Subject: Plan Approval for Reconstruction of Lake Irogami Water Control Structure
Dam Key Sequence Number (DKSN) 6266

8/13/2019

WEIR ON LAKE IROGAMI (PROPOSED)

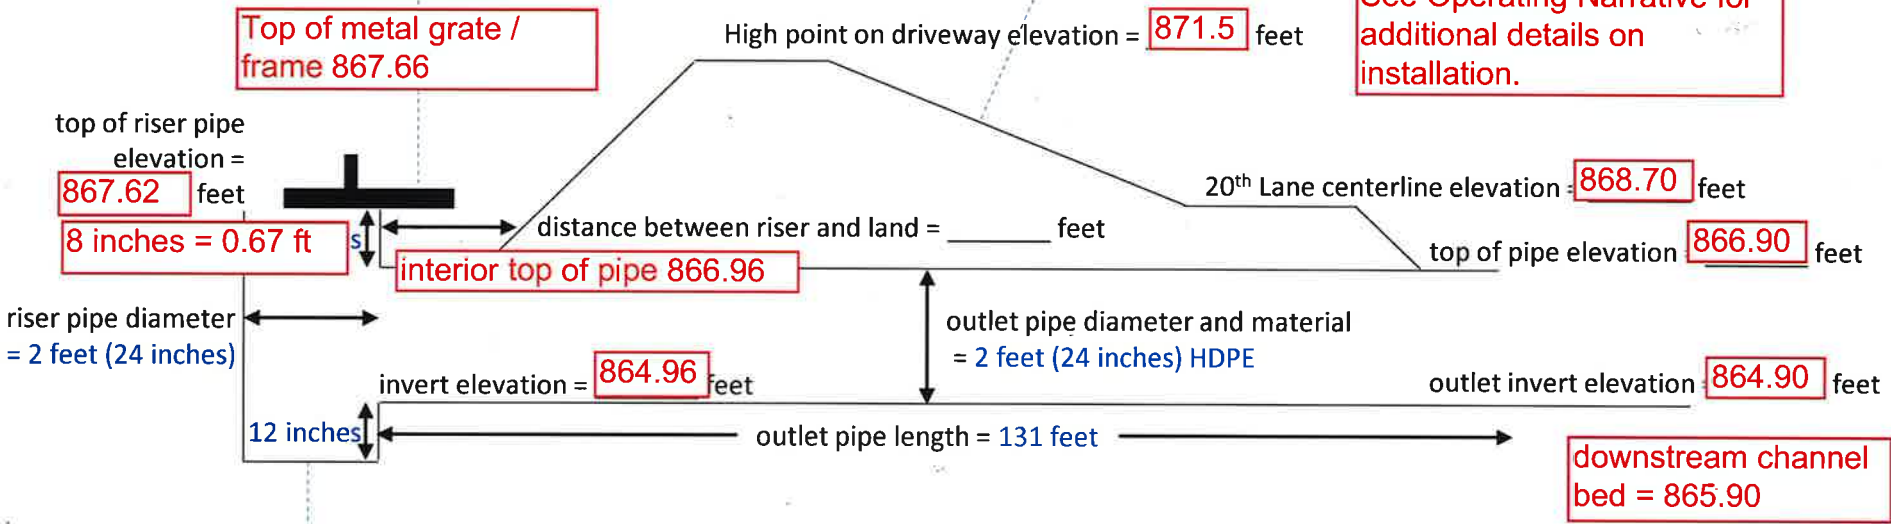
- Attach slide gate and barrier dimensions, describe how gate attached to riser, locking device, etc.
- Attach description of when and how gate is operated
- Describe how flow meter to be used (e.g., model, where measurement taken and recorded, frequency, etc.)

- Describe how driveway will be restored
- Describe which, if any, trees will need to be removed as part of the project

Describe connection and base: Fill 12 inches with rock and concrete so that bottom of riser ≈ invert elevation

per ADS standards, 1 foot minimum cover over 24" HDPE pipe required

Install minimum two bentonite anti-seep collars ("seals") on horizontal pipe. Bentonite to be formed into circular plug with 18" minimum thickness and extending out 2 feet from outer edge of pipe. One collar shall be located 7 to 10 ft from weir intake, the other one 20 ft downstream of that point.

- Sandbags to be placed across ≈ 5.5 foot wide opening to lake
- Riser area to be dewatered using pump prior to removal
